**Landmarks & Urban
Conservation Commission**

**Agenda Number: 6
Case No.: 17-LUCC-50006
Project # 1004847
March 8, 2017**

Staff Report

1. This application is a request for a Certificate of Appropriateness for new construction at 401 Walter St. SE described as Lot 1, Block 18 of the Huning Highlands Addition, a property in the Huning Highland Historic Overlay Zone, zoned SU-2/MR.

Roof Detail
ATTACHMENT A-1

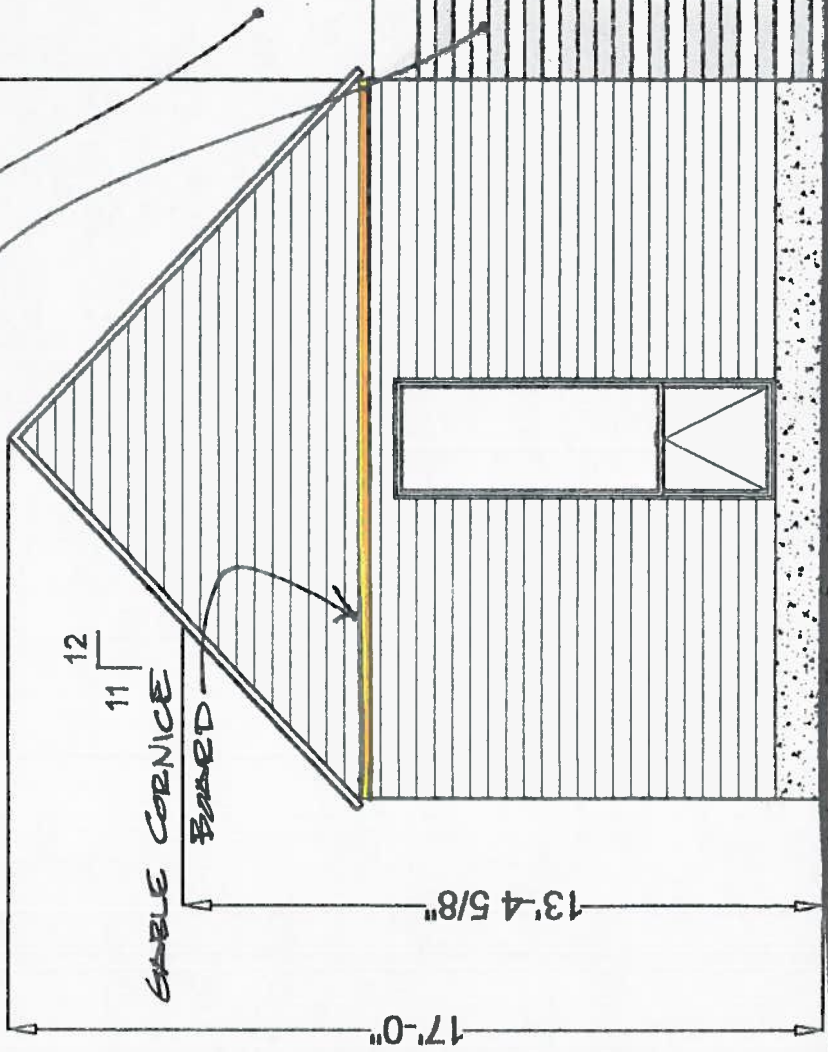
Although it is subservient to the larger flat roofed mass, the smaller mass closer to the sidewalk on Walter provides a gable end pitched roof. The connection between the two masses is very uncomfortable as it looks as though one is sitting next to the other and not forming a cohesive whole. The roofing detail at the area might also pose a problem as water will want to pond at the joint.

Although the area of connection is small, approximately 16', the addition of a pitched roof addition perpendicular to the gabled roof would ease the transition between the two masses and potential relieve future water problems. (See Attachment A-1)

ADD ROOF BRIDGE

9. The proposal is substantially compliant with guideline #6 for roof design. The design includes both flat and pitched elements; however, the connection between the two fails to integrate the design into a cohesive whole, making the pitched roof to look an afterthought. An additional pitched element, perpendicular to the one currently proposed is required to blend the two elements into a single unit.

SABLE CORNICE BOARD
ATTACHMENT A-2

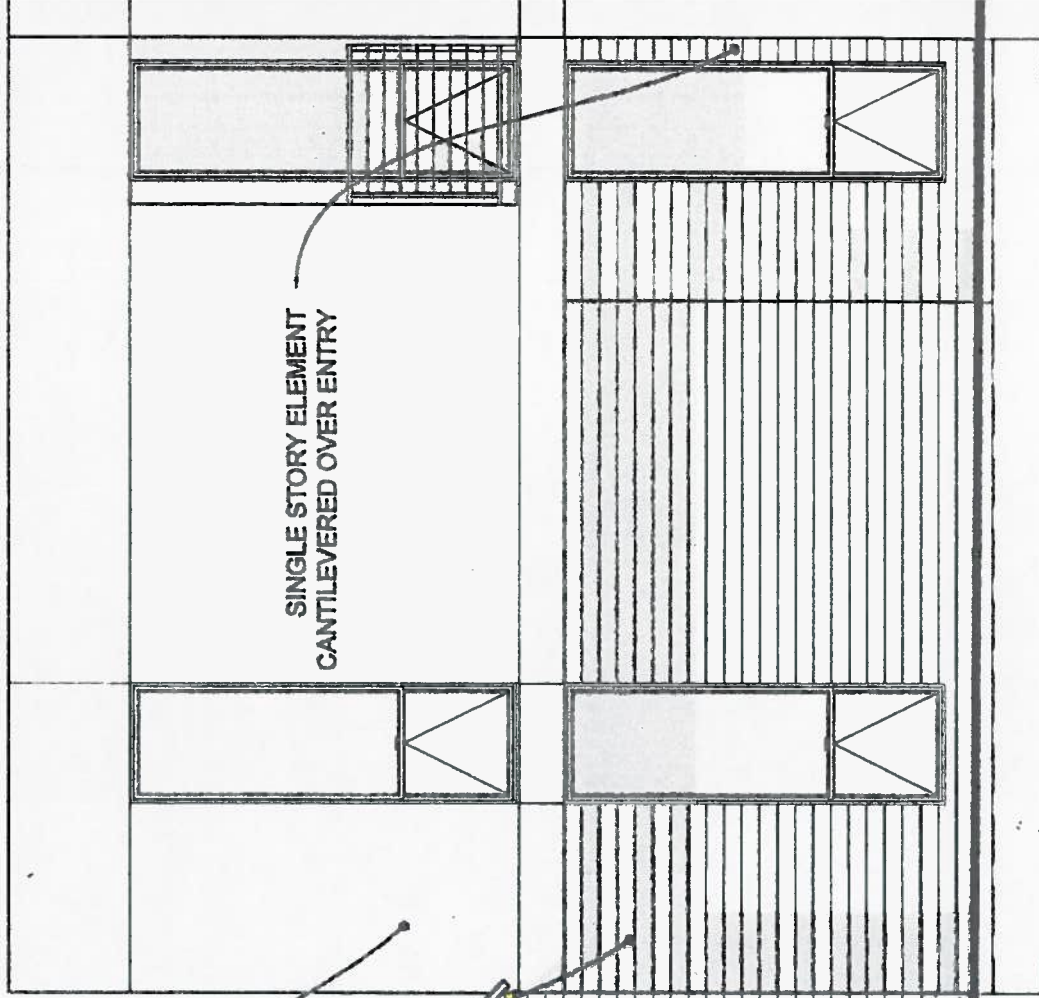
Materials on the project, as mentioned previously, complement those materials used in the neighborhood on historic properties. Fiber cement lapboard panels, laid horizontally, are visually similar to what is currently found on houses, as is the stucco. One element lacking from the pitched roof mass is a horizontal cornice board across the base of the triangular gabled end. This would add definition to the elevation, tying it into similar elements seen on the street. (See Attachment A-2)
